1958 Corvette: Service Bulletin: Electric Windshield Wiper Information

Subject: Electric Windshield Wiper Information
Model and Year: 1958 Passenger Cars and Trucks
Source: Chevrolet Technical Service Bulletin
Bulletin No: DR #359
Section: I
Date: May 28, 1958

FIGURE #1.

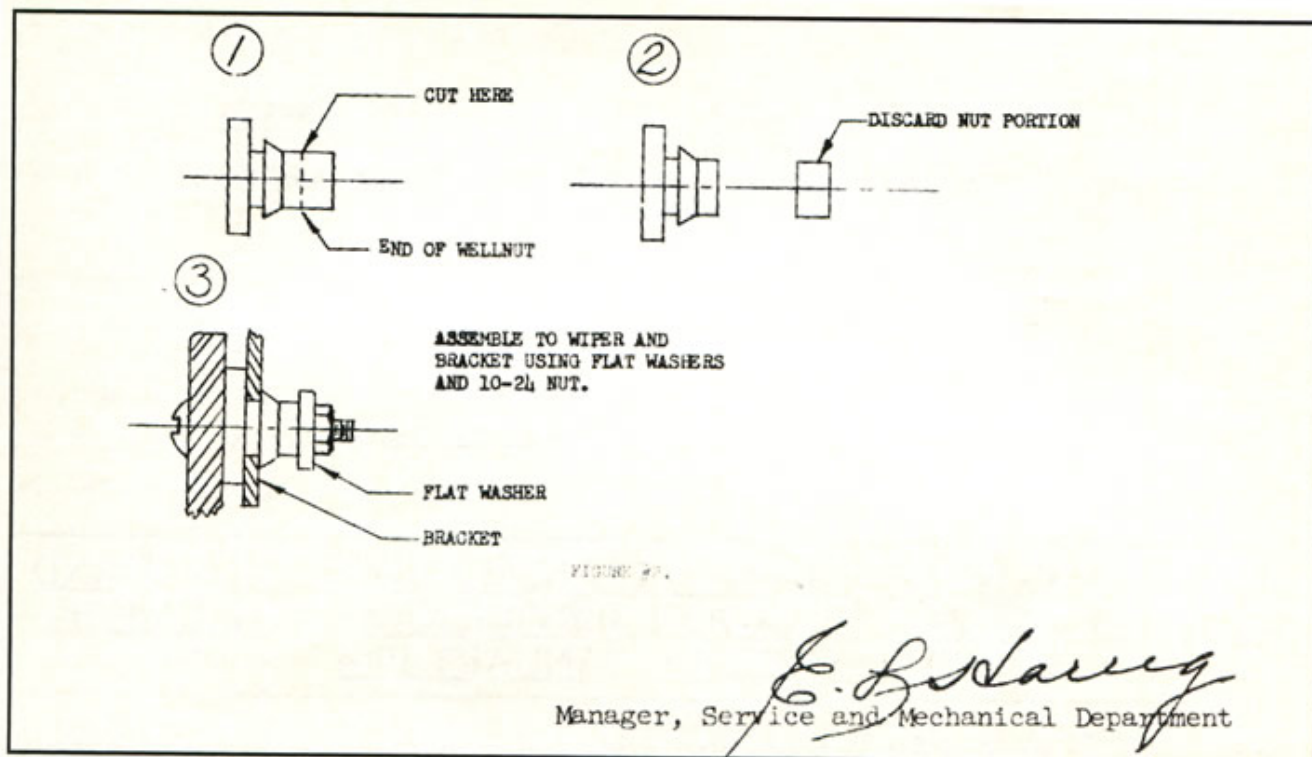
In some cases the wiper motor, after being shut off, may over travel the effective length of the parking cam and continue to run in a reverse direction. This condition may occur even though the blades are properly positioned as covered in TSB #508, DR #359.

If the right hand blade slaps against the moulding excessively even though the blade is correctly positioned and parks properly, the upper cam stop is probably bent or broken. This damage can occur if the mechanism is coated with ice when the wiper is turned on.

A parking spring has been released for production and service which enables the motor to shut off without depending on the resistance of the wiper blades. The spring is designed to clear the revolving arm in the "ON" position and stop the arm in the "PARK" position when switch is turned off. Figure #1 shows installation of parking spring.

A more durable replacement cam stop is available for service. Figure #1 shows details of installation. The existing tab must be bent flat before installation of the new stop.
